Important Information — Dell OptiPlex 790/990

System Board

Figure 2. System Board with the thermal sensor and heatsink removed

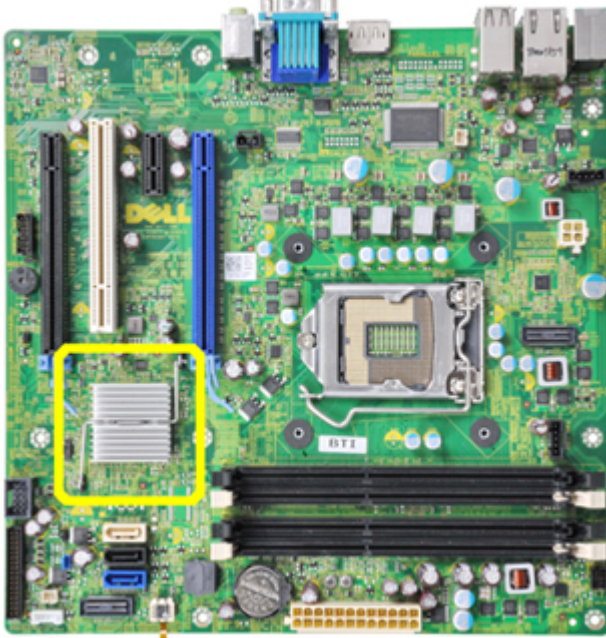
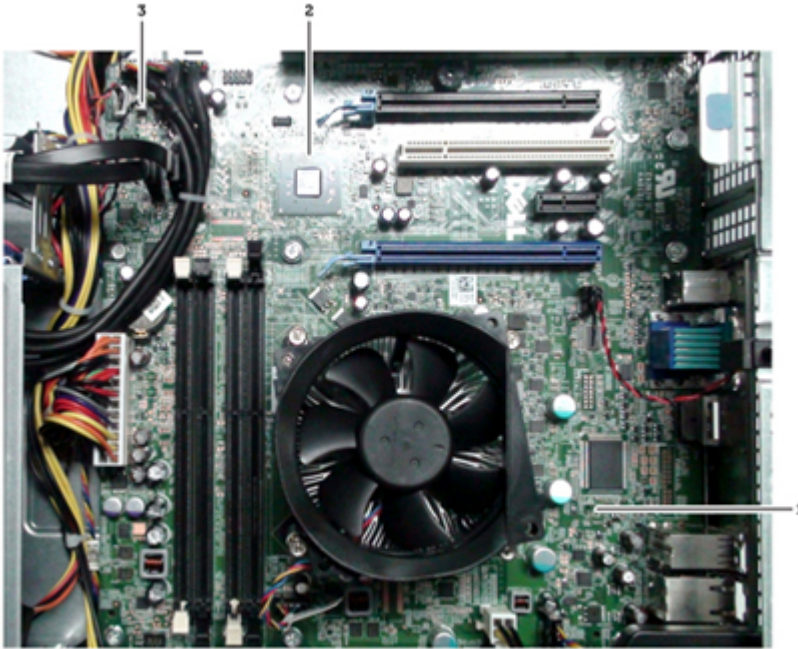
The Dell OptiPlex 790/ 790 computers are now shipped with a new system board without the following components:

1. Heatsink
2. Power supply thermal sensor (Desktop chassis only)

Heatsink Removal

The following image displays an earlier version of the system board shipped with the heatsink.

Power Supply Thermal Sensor Removal

The power supply thermal sensor is removed from the desktop chassis only.

1. thermal sensor connector-1 and cable removed
2. chipset heatsink removed
3. thermal sensor connector-2

All system boards shipped with the following BIOS versions or higher will NOT contain the heatsink.

NOTE: If you have replaced your system board with a new system board for the Desktop chassis, always ensure that the BIOS version is A11 or higher.

WARNING: If you do not update the BIOS, you may receive Alert! Chipset heat sink not detected error message during the power-on self test (POST).
